**For Pre-Decision Scrutiny by the Environment PDS Committee on:**

**Date:** 15th March 2018

**Title:** LOWER SYDENHAM TO BROMLEY QUIETWAY PUBLIC CONSULTATION REPORT AND FINAL PROPOSALS

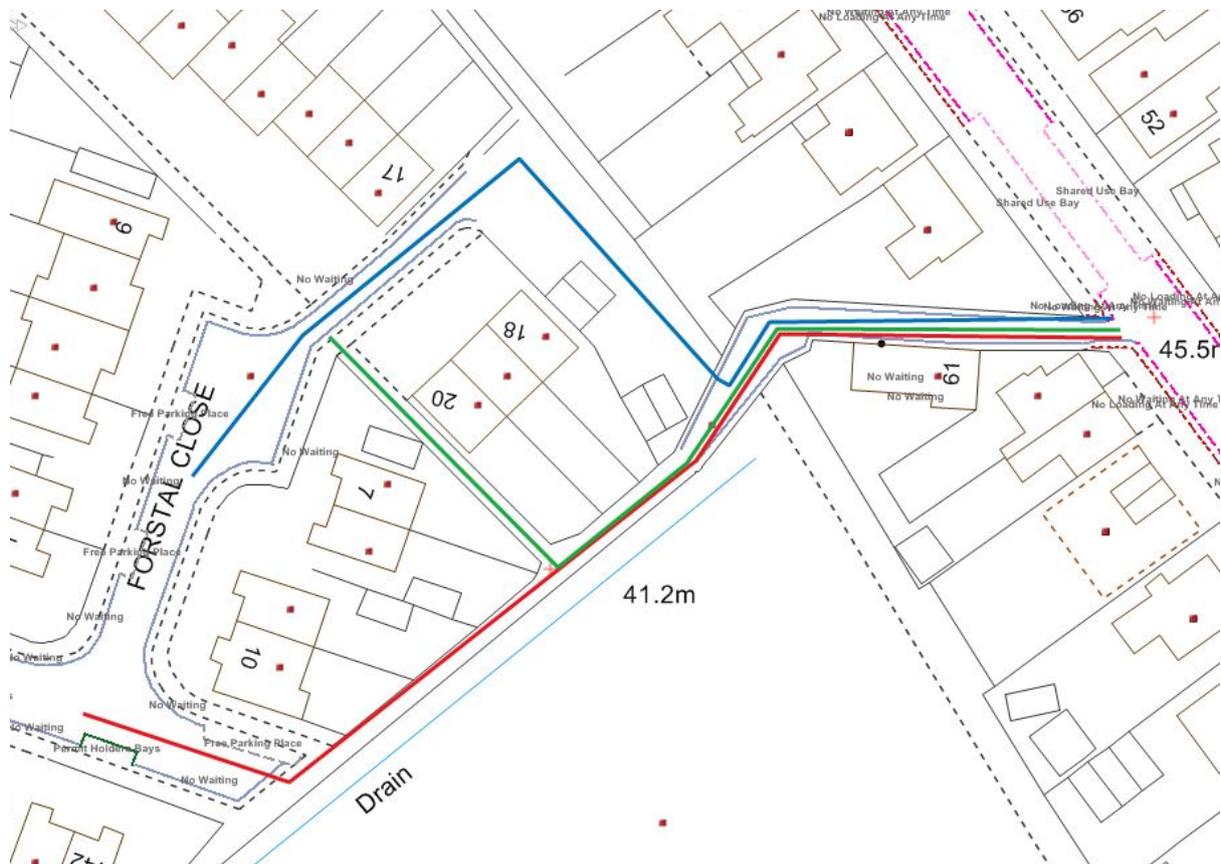
**Worsley Bridge Road shared path-** Implement as proposed with minor modifications based on consultation comments
